**Squeaks & Rattles – Airbag Door –
Adjusting Clearances**

MODEL 1995 MY
Sedan Range
VIN
720001-743138

ILLUSTRATION 1

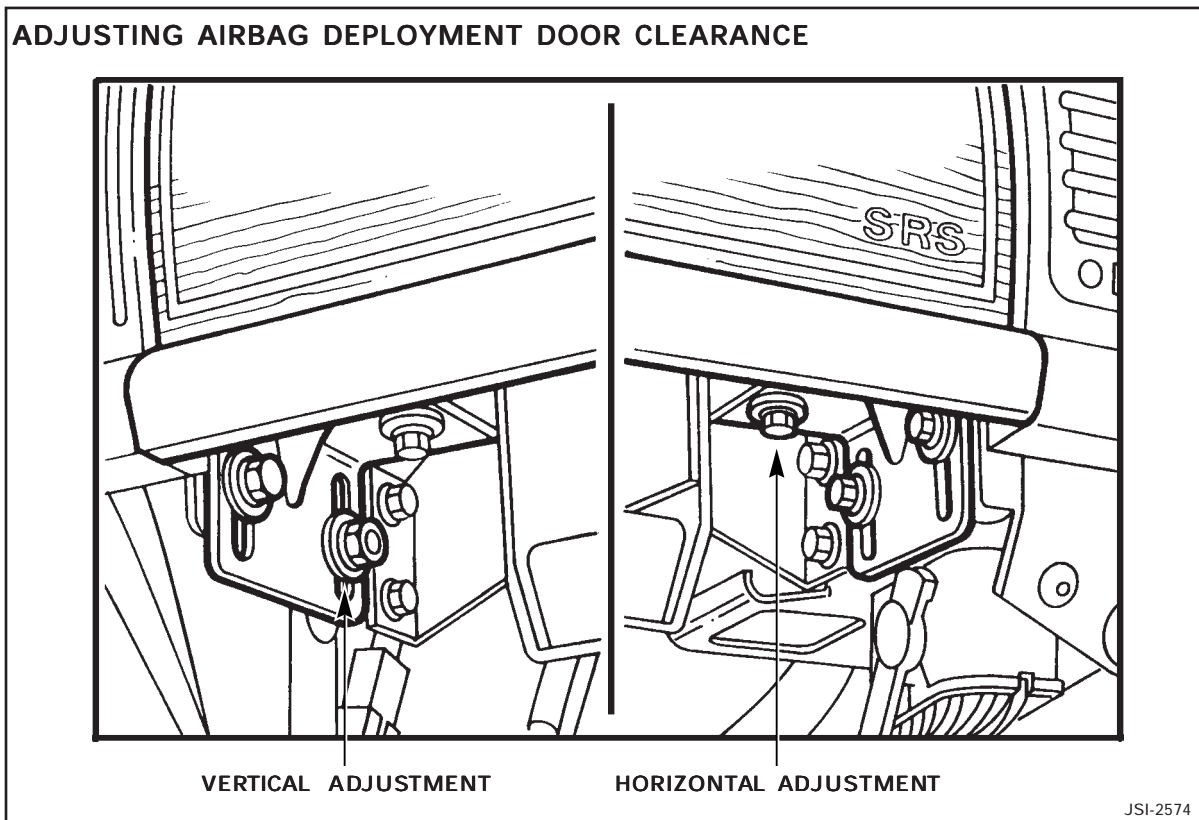
Some 1995 MY Sedan Range vehicles within the above VIN range may experience squeaking from the airbag door rubbing against the adjacent fascia panel veneer. This condition can be repaired by realigning the deployment door.

- Remove the underdash liner (up to VIN 739426) or the glove box (VIN 739427-ON),
- Vertical adjustment of the door assembly is made by loosening the four horizontal bolts (Illustration 1).

- Horizontal adjustment of the door assembly is made by loosening the four vertical bolts (Illustration 1). These bolts allow adjustment both left and right and in and out.
- Torque the bolts to 39 - 44 lb. inches (4.5 - 5 Nm)
- When installing the airbag door, note the following:
 - the door should be centered in the opening
 - the bottom trim roll of the door must align with the bottom trim roll of the fascia.
 - the door veneer must be level with the adjacent fascia panel veneer at all points.
